**TYRONE TOWNSHIP
REGULAR BOARD MEETING AGENDA
JANUARY 18, 2022 - 7:00 P.M.
(810) 629-8631**

Lake Urban Crossing PUD Preliminary Site Plan

**Subject: Agenda Request, Lake Urban Crossings Preliminary PUD Plan
Recommendation for Approval**

PRELIMINARY FIRE TRUCK ROUTE PLAN LAKE URBAN CROSSINGS

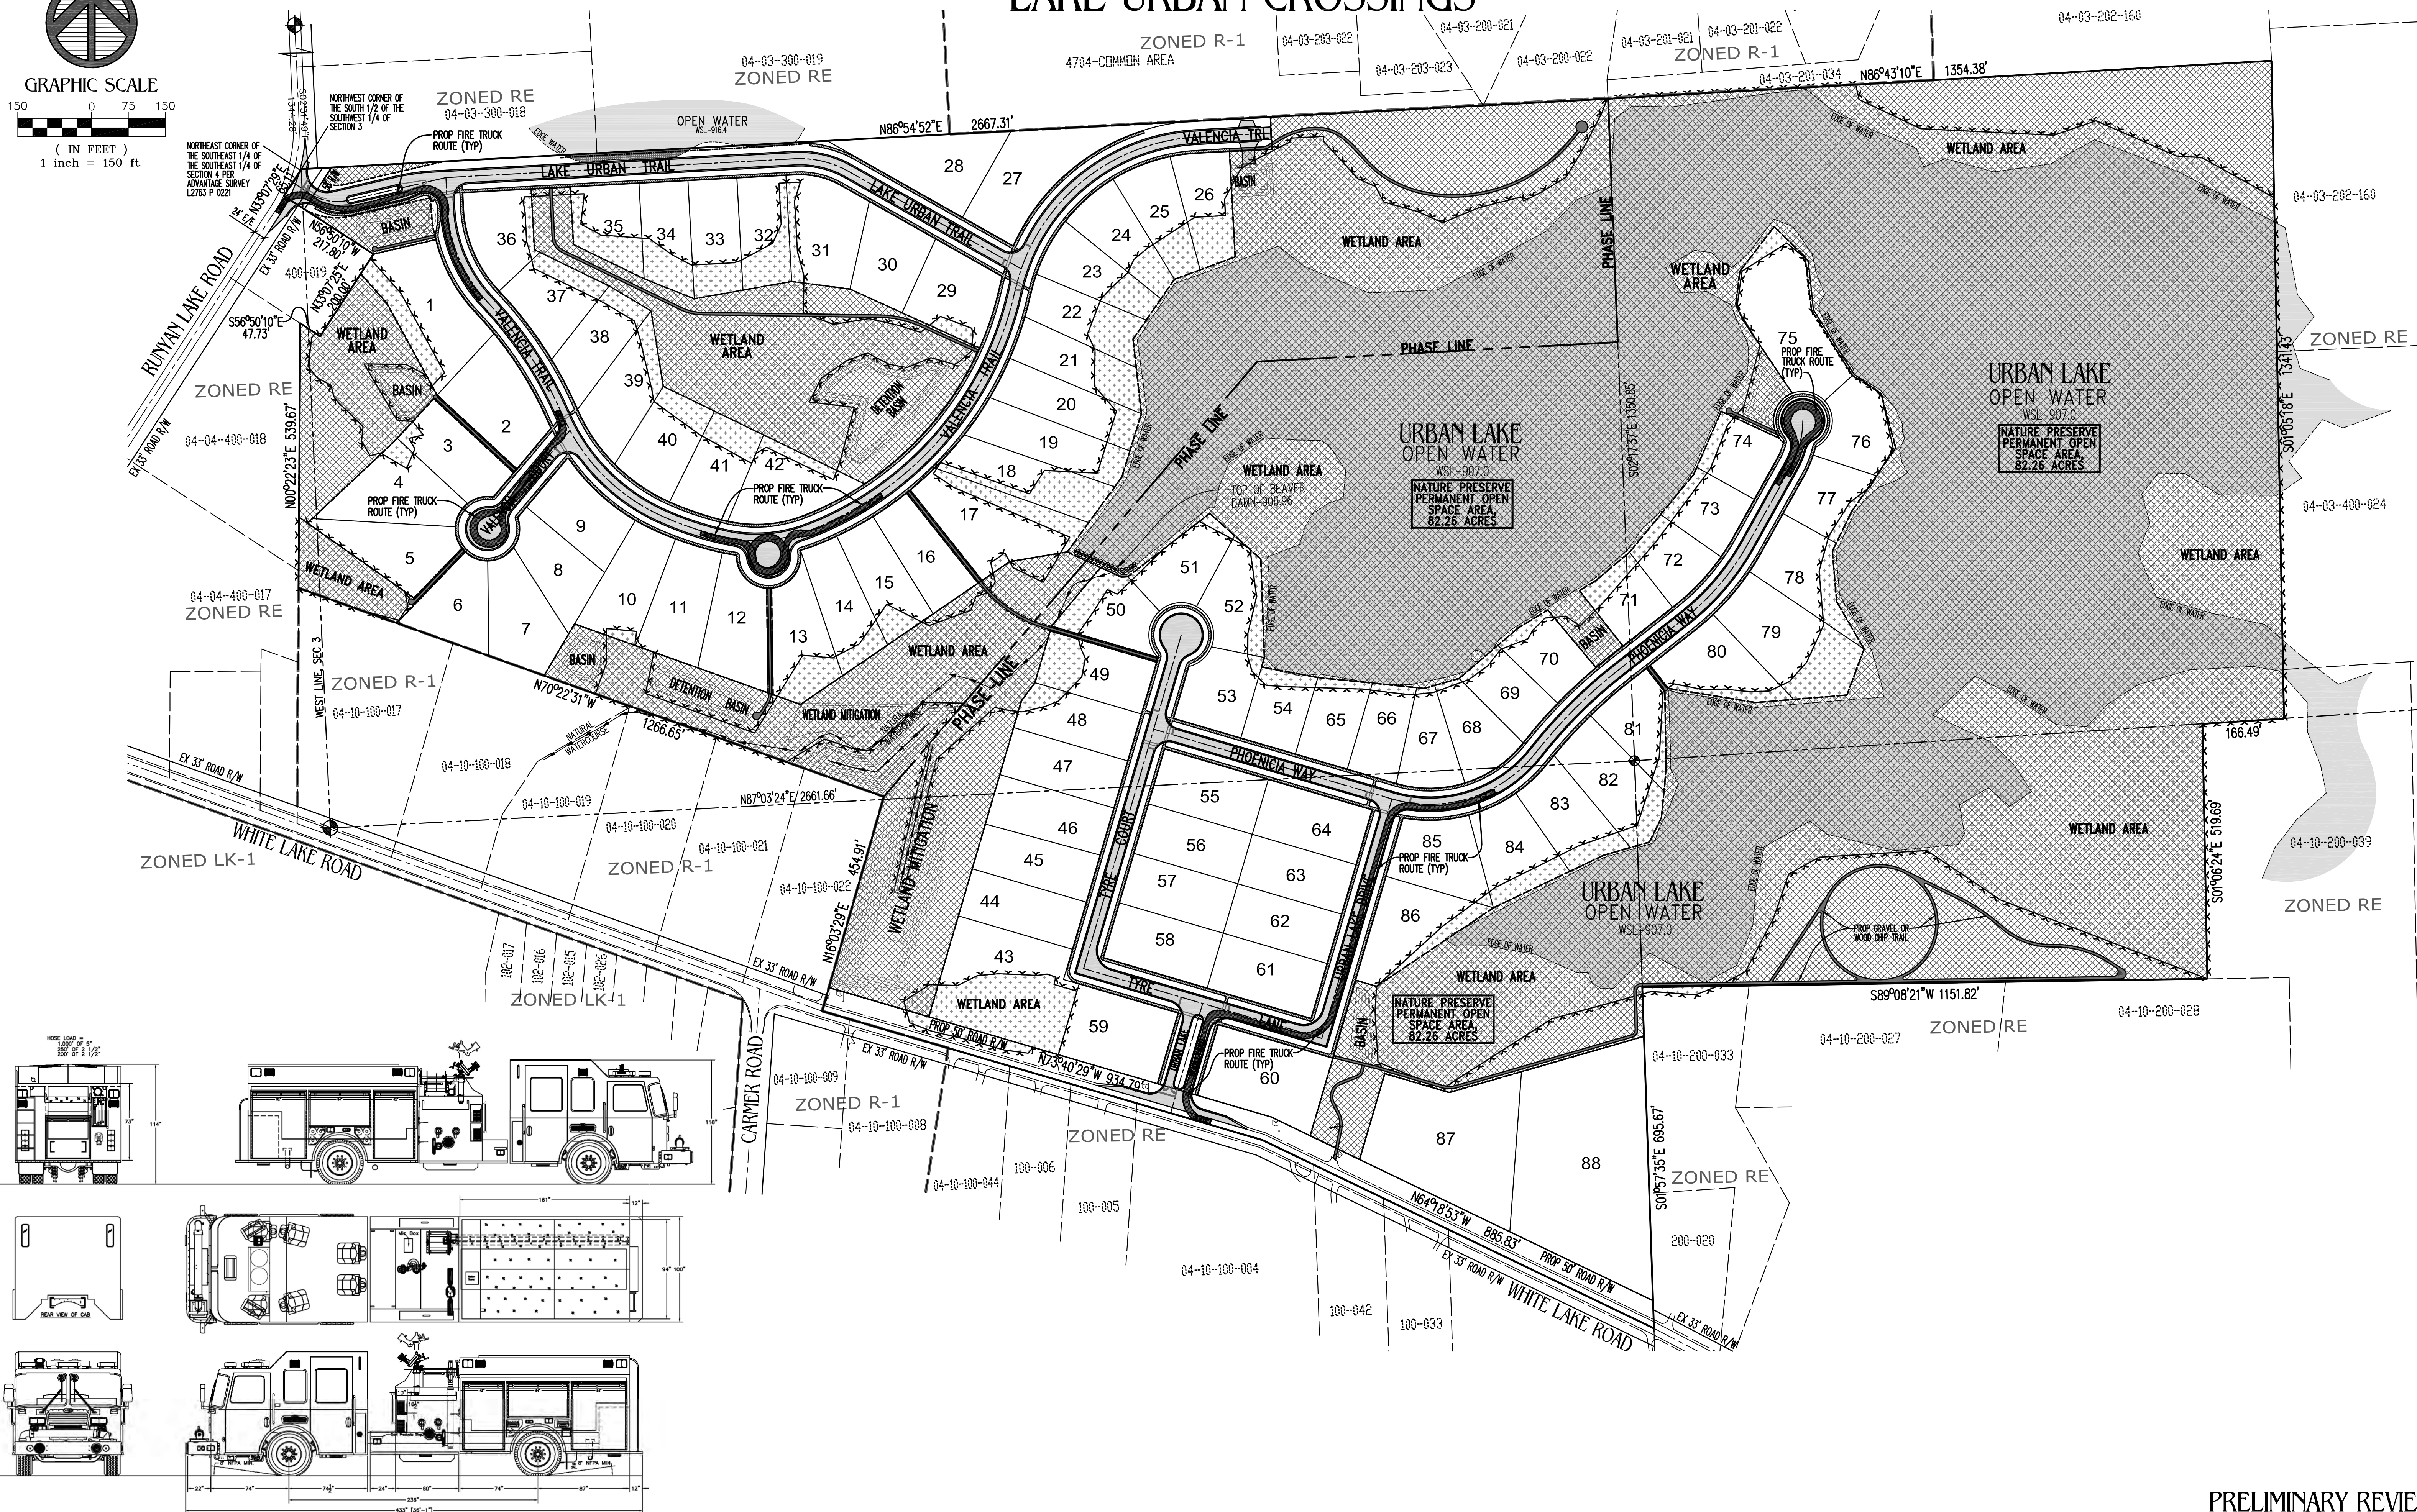
Comments: *The proposed road system would allow direct access to all of the proposed lots. Sheet P-8 shows fire apparatus access through most of the site. It is likely that a turnaround will be required at the eastern end of Valencia.*
